BISHOP GRANDIN WALK BIKE BRIDGE OVER PEMBINA HIGHWAY PUBLIC WORKSHOP SUMMARY

June, 2017

Bishop Grandin Walk Bike Bridge Over Pembina Highway

Appendix B – Alignment Options

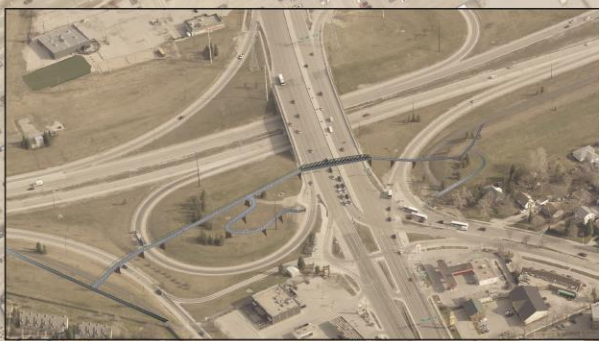
What We Heard	How It Was Considered*
Participants preferred Alignment 2 as it is a straighter route, has better sightlines, and is shorter.	Alignment 2 was selected for the preliminary design.
Participants least preferred Alignment 3 due to seemingly higher costs, potential for spring flooding, greater traffic interruptions, lessened user experience, and perceived security concerns.	Alignment 3 was not carried forward to the preliminary design.
Participants noted access issues to the University of Manitoba and Investors Group Field via University Crescent on all three options.	Access to University of Manitoba and Investors Group Field will be considered in future walk bike upgrades to University Crescent.
Participants preferred Bridge Concept 3 as it is more aesthetically pleasing, fits in with the existing neighborhood, complements the adjacent landmarks, provides good visibility, and feels more open.	Bridge Concept 3 was selected for the preliminary design.

Alignment 1

- Should alignment 1 be further north to access Plaza Station?
- Alignment 1 – more accessible to pedestrian bus stops
- Stairs to bike path with bike trough
- Tight turns are okay but not so tight that you have to stop

Alignment 2

- Good for cyclists
- Longer walk for pedestrians
- Transit must be included
- No stops for cyclists

Alignment 3

- Drivers are not always thrilled with cyclists and tunnels and this alignment may lead to more traffic disruption
- This alignment is not popular with the group
- There needs to be smooth transitions from the access ramps

- Access issues via University Crescent to U of M and IGF – inconvenient
- Grade and accessibility west side slope
- Maintain path by Barley Brothers as it provides access to southbound Pembina and University Crescent
- Overall length issues for users traveling east/west

- Appears to be more convenient
- Least disruptive and least time to construct
- Access issues via University Crescent to U of M and IGF – inconvenient

- Drainage is a big issue after heavy rains.
- The user experience lessened by going through tunnels
- Closer to Bishop Grandin
- Access issues via University Crescent to U of M and IGF – inconvenient

- More direct
- Like the look of a straight, more direct path
- Would like an Active Transportation pathway alongside northbound University Crescent
- Better sightlines
- Pembina highway access may be steeper
- University Crescent access is an issue on all three options (going south to U of M)
- High traffic down University Crescent is a potential safety concern for all three options during school hours and Blue Bomber game days

- Do not like tunnels
- Security concerns with tunnels
- Drainage concerns with tunnels
- May flood in the spring as do some other tunnels in Winnipeg
- Cost is higher
- University Crescent access is an issue on all three options (going south to U of M)
- High traffic down University Crescent is a potential safety concern for all three options during school hours and Blue Bomber game days

- 5% or less
- More curvy so slows cyclists down
- 30 meters longer than alignment 2
- Option 1 doesn't help the 7 crossings for pedestrians to catch the bus at Pembina Highway and University Crescent
- Width is 5 m
- Should have cyclist and pedestrians separated
- Connection through green space at the on ramp is not as useful. Might be nice for pedestrians

- 30-40 m shorter than alignment 1
- Less convenient for pedestrians crossing Pembina Highway

- Very direct
- Less visible from the roadway
- Security concerns with the tunnels
- Least helpful for people crossing Pembina Highway
- Ice buildup in tunnels is a concern
- Spring time maintenance is a concern
- More sheltered, less windy
- More snow drifts because this alignment is at ground level
- Increased noise under the bridge but peaceful in the green space
- Pedestrian connections are important at Pembina
